HAM-VINE STREET NS

General Comment:

Given the geometric issues discussed on 9/4/24, between ORDC, D8, M&H, and Woolpert, the Stage 2 plans will need to be re-submitted showing the revised roadway design, accommodating the proposed truck turning arrangements, proposed by Woolpert.

TITLE SHEET

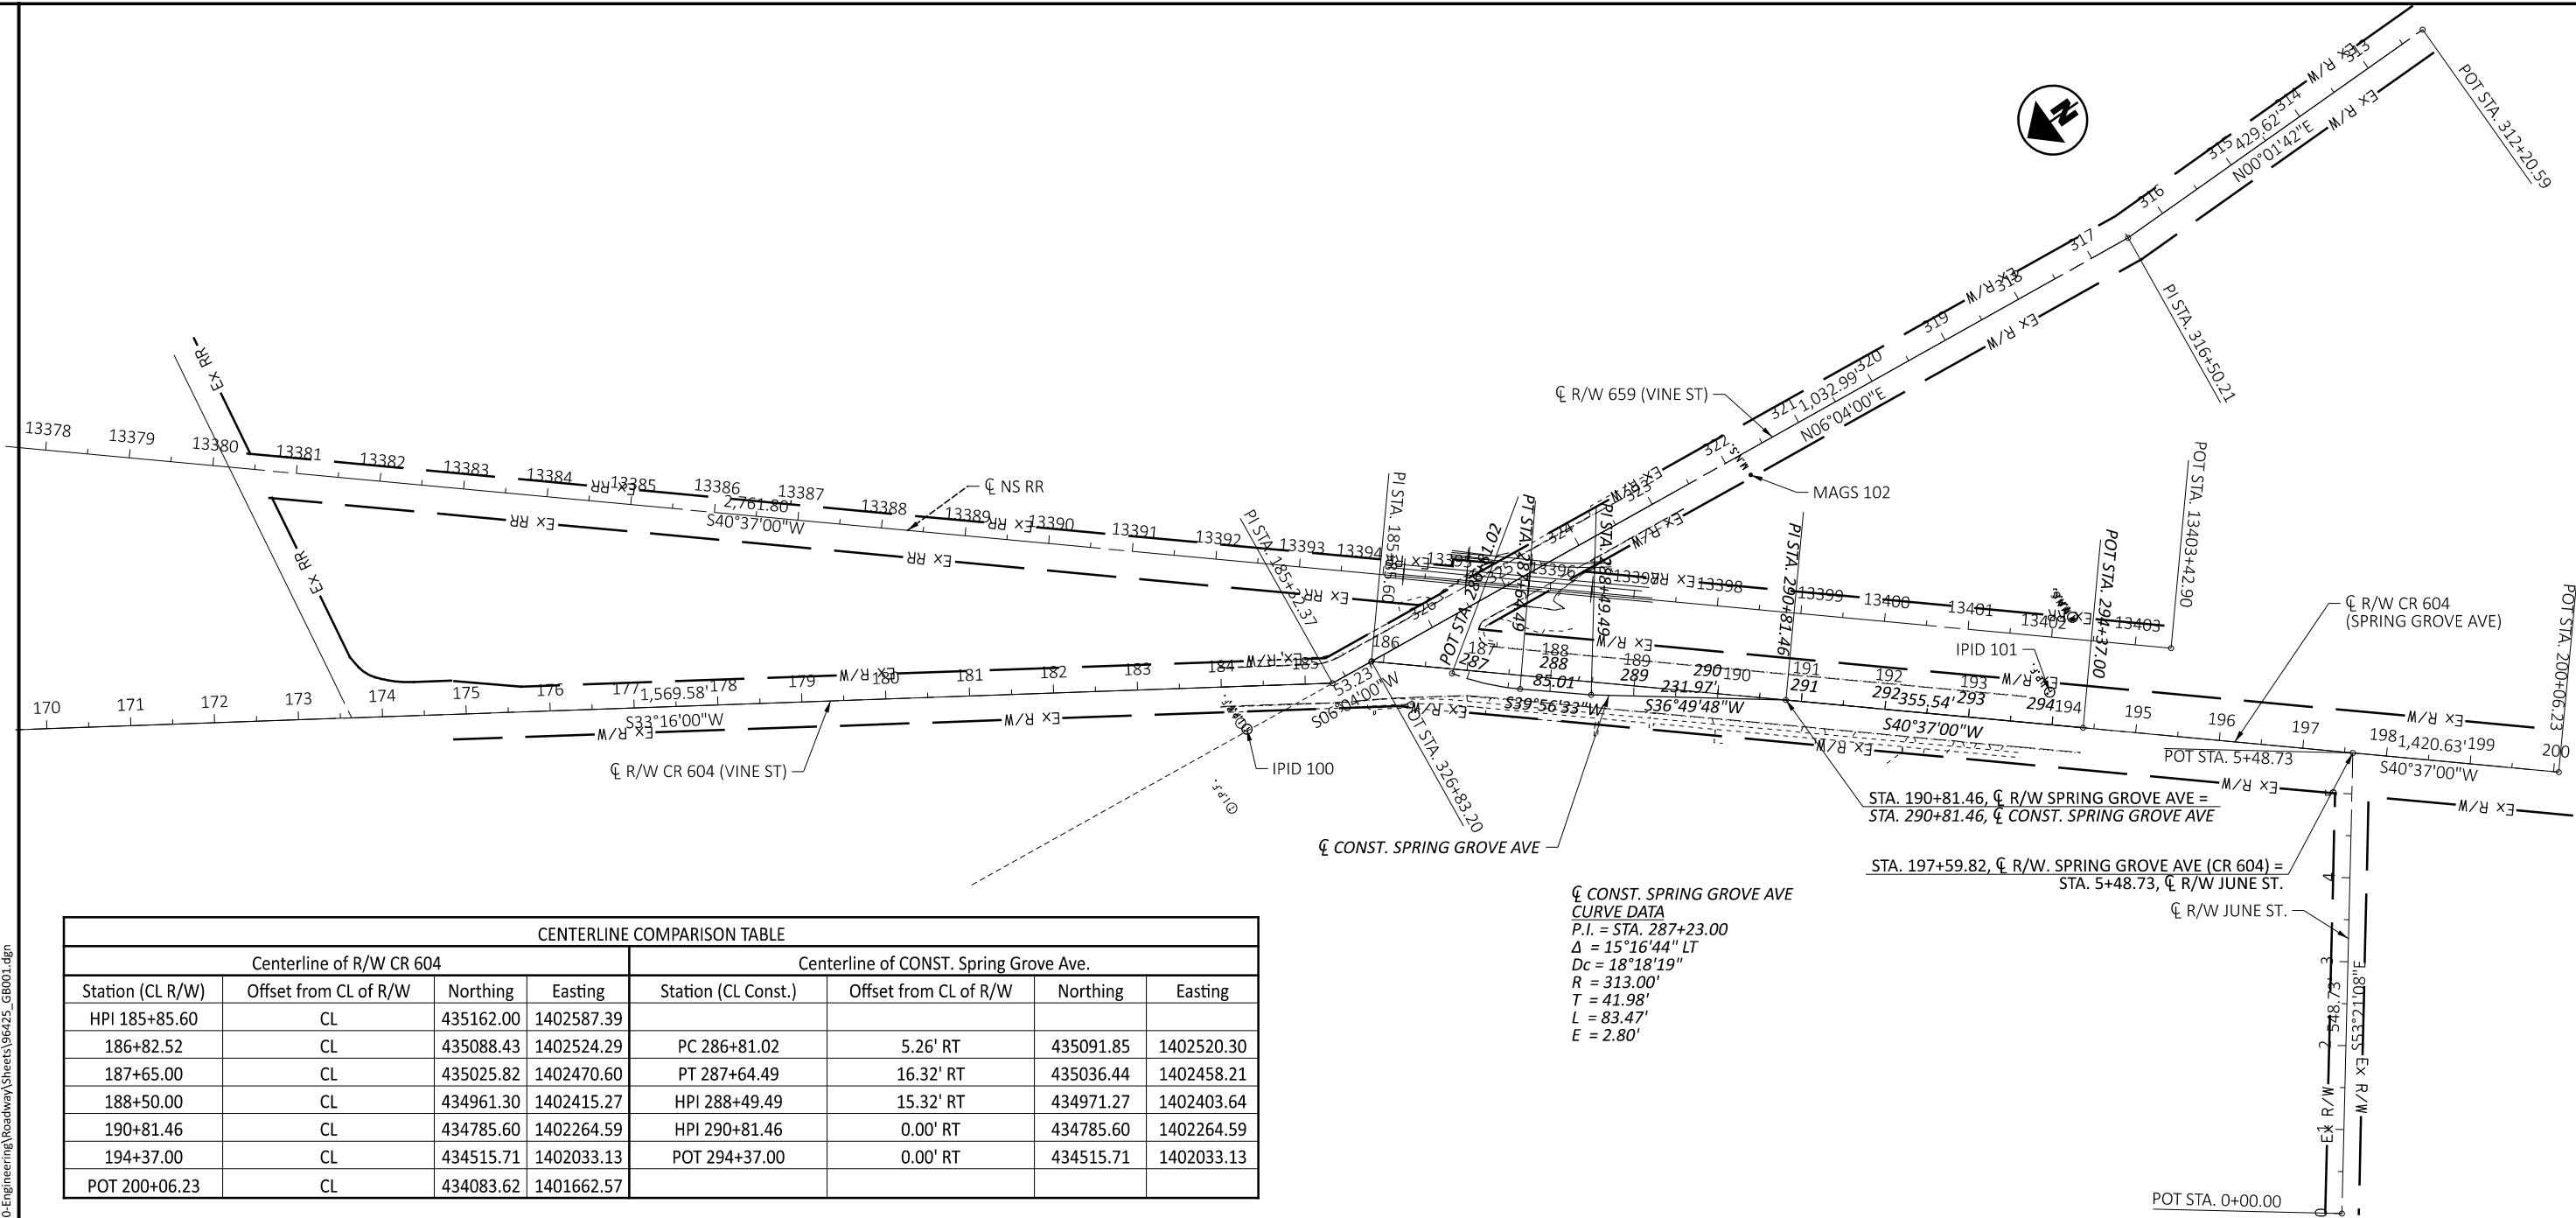
see comments on
drainage report

update dates

SHEET TOTAL
P.03 | 35

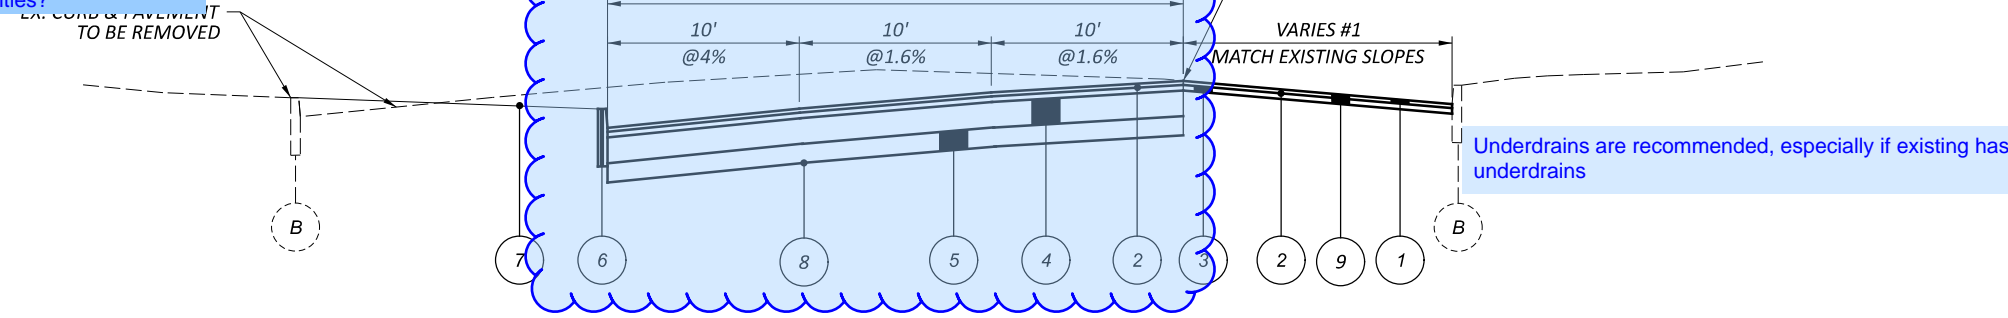
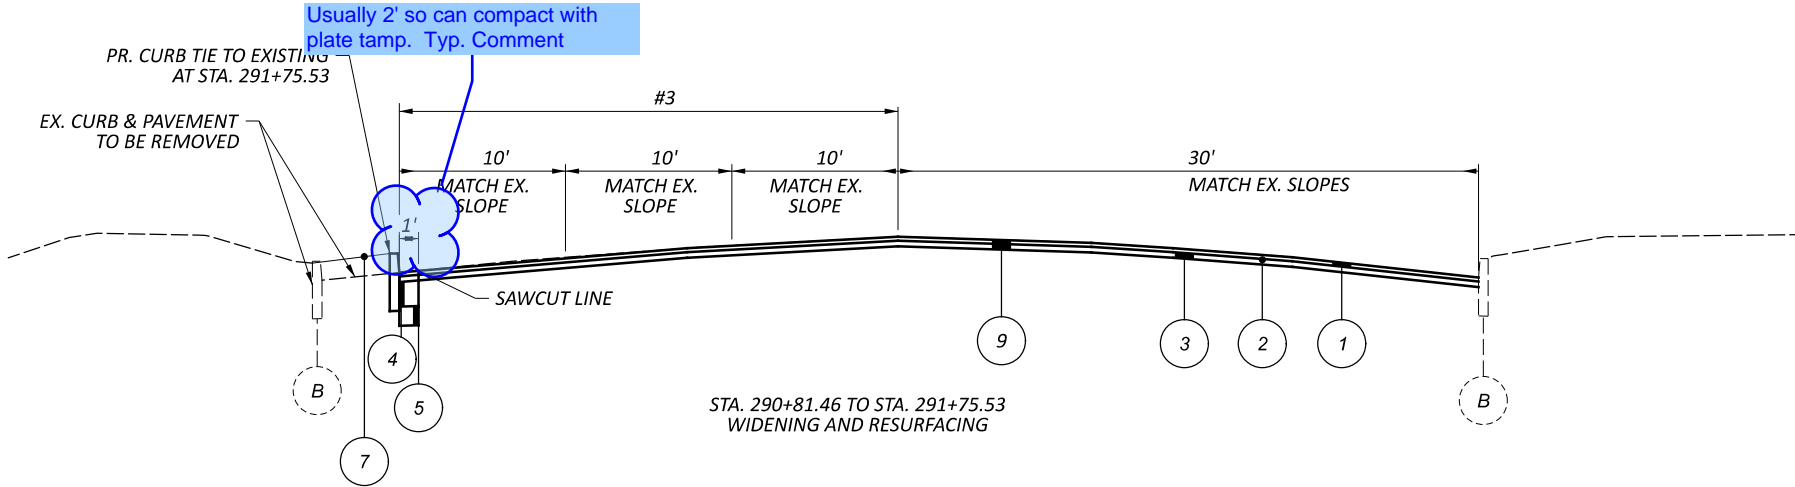
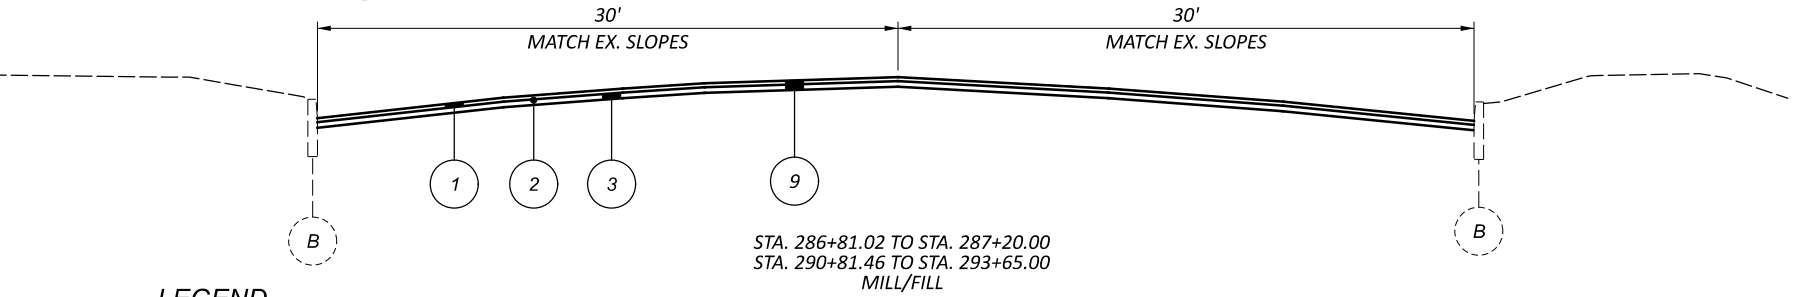
Issues with existing utilities? If no direct conflict with utilities, enough clearance to complete work...i.e. compact subgrade without damaging utilities?

Underdrains are recommended, especially if existing has underdrains

Usually 2' so can compact with plate tamp. Typ. Comment

Missing subgrade compaction.
Subgrade treatment needed?

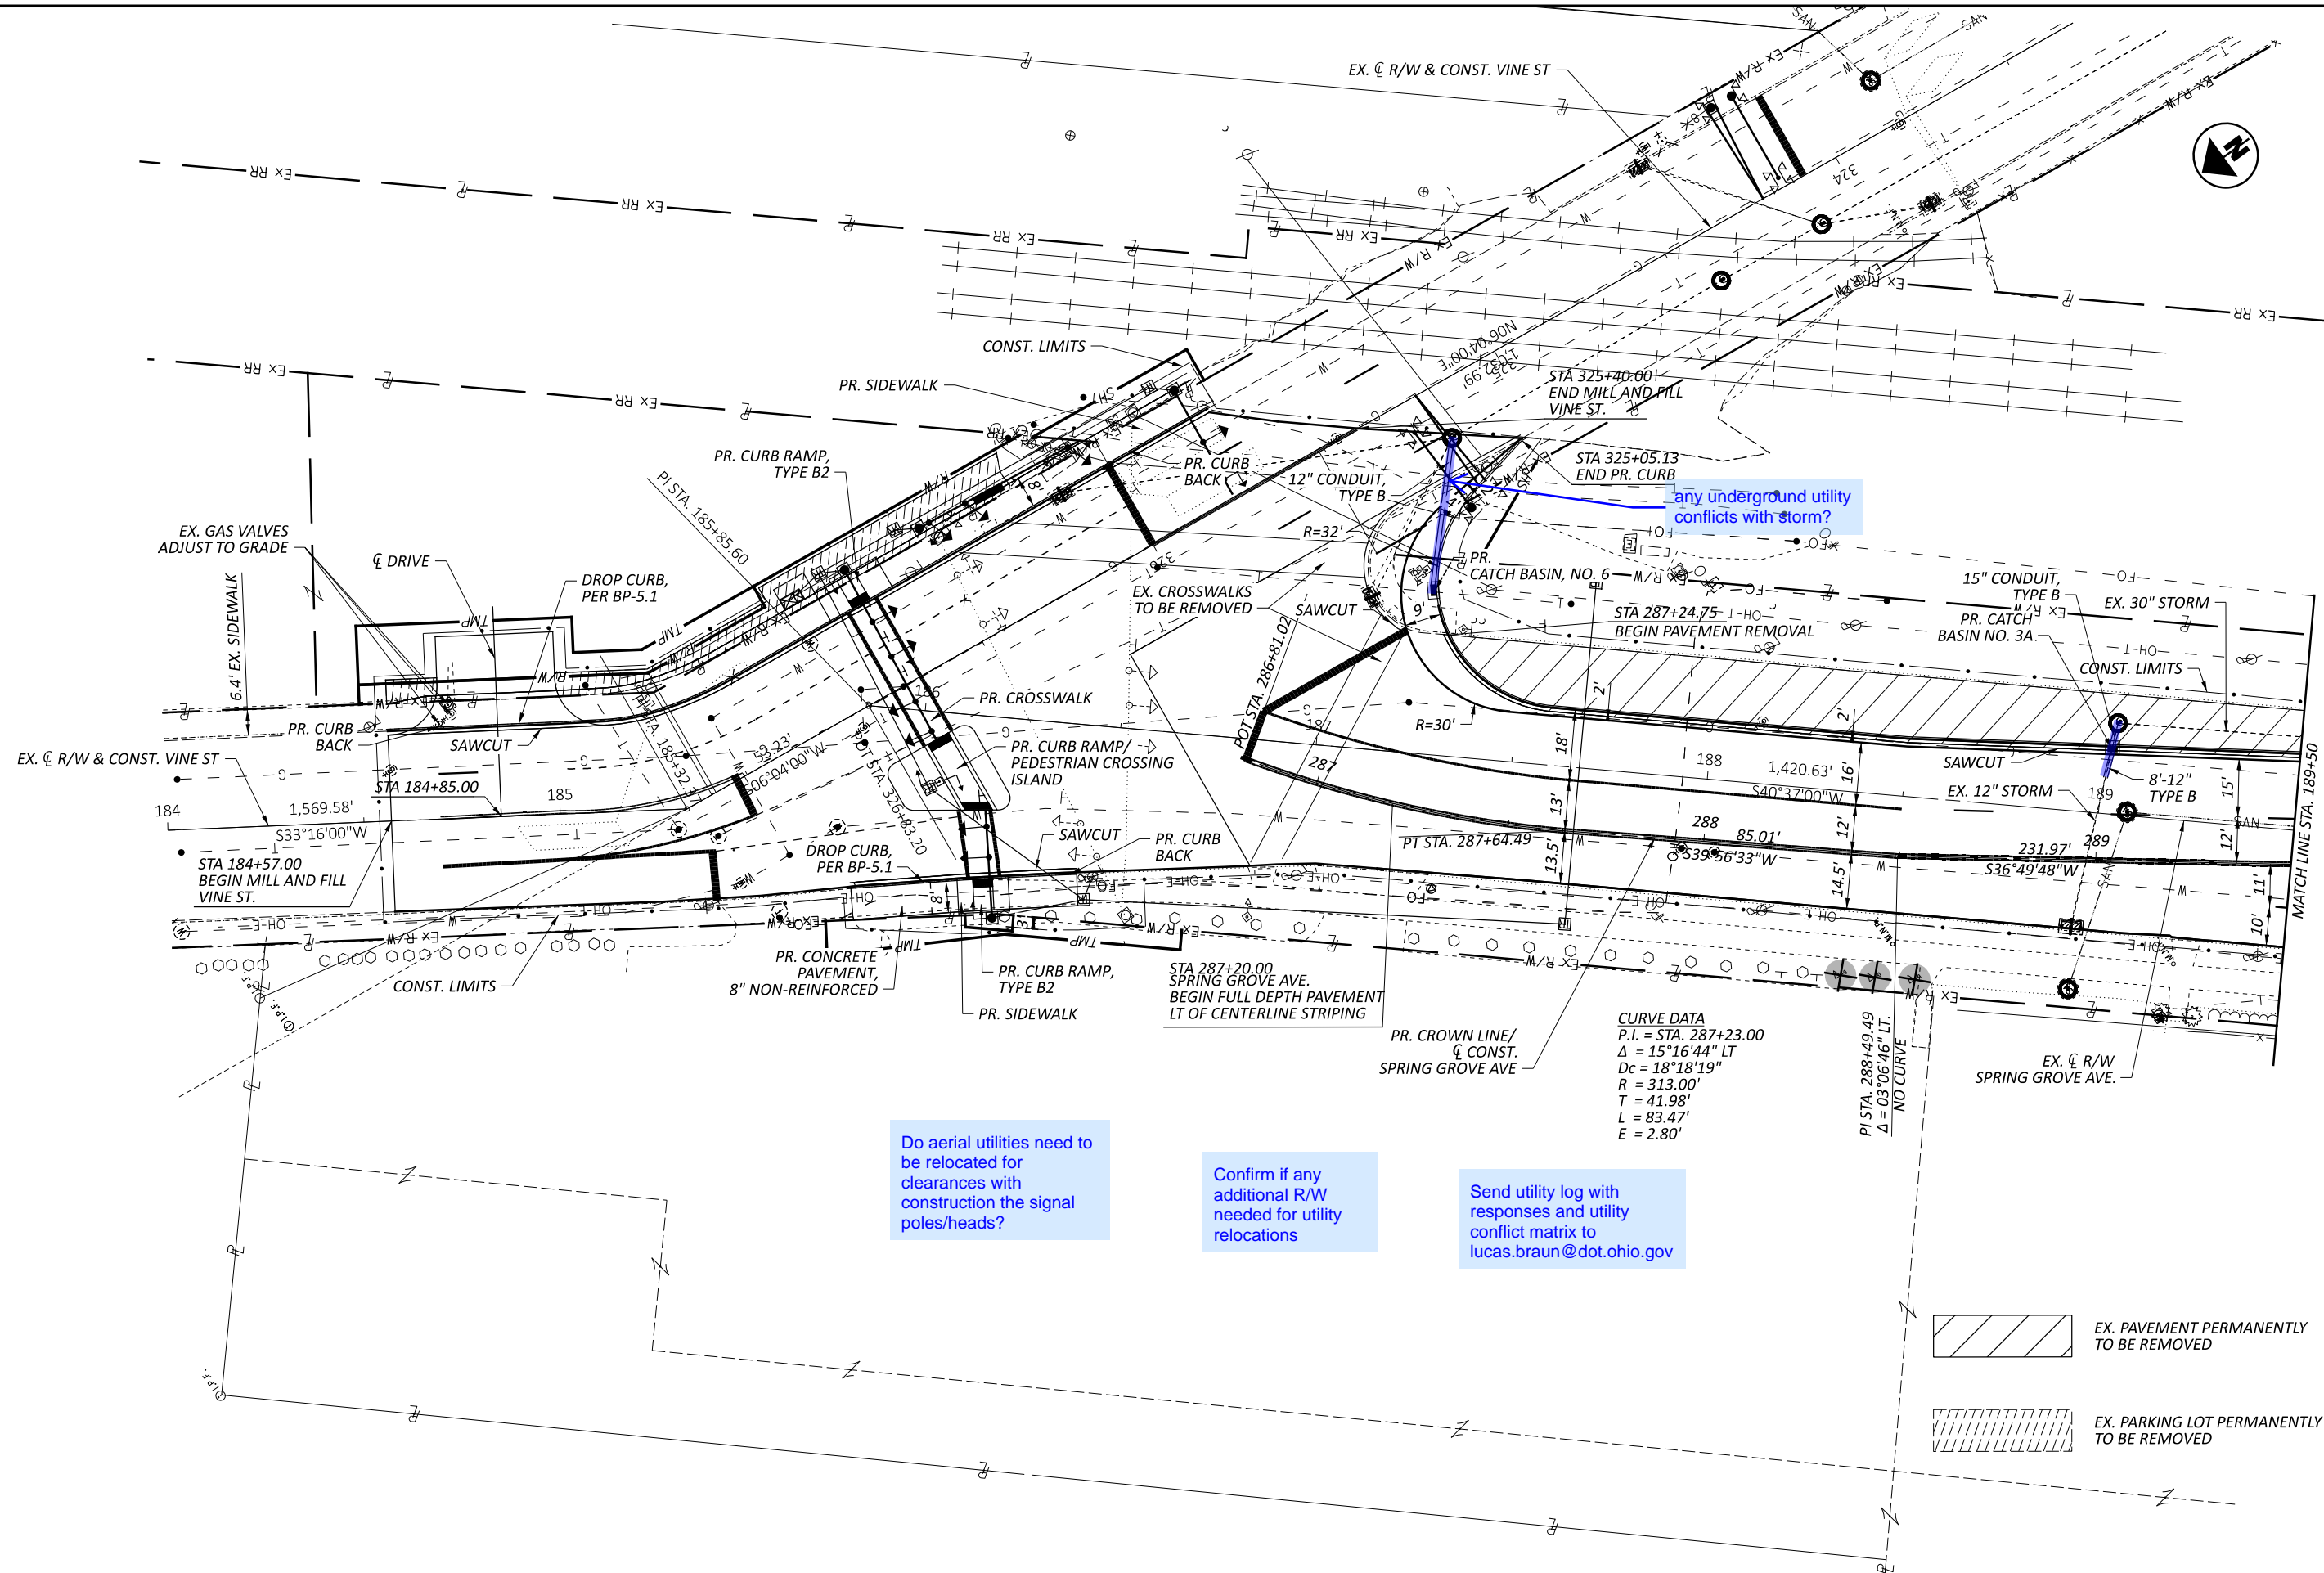
Add Norfolk Southern Project Coordination Note...See PID 110570 page 8 for example.

Add Railroad Project Coordination Note...see PID 110570 page 8 for example. Change schedule requirement from monthly to every 14 calendar days.
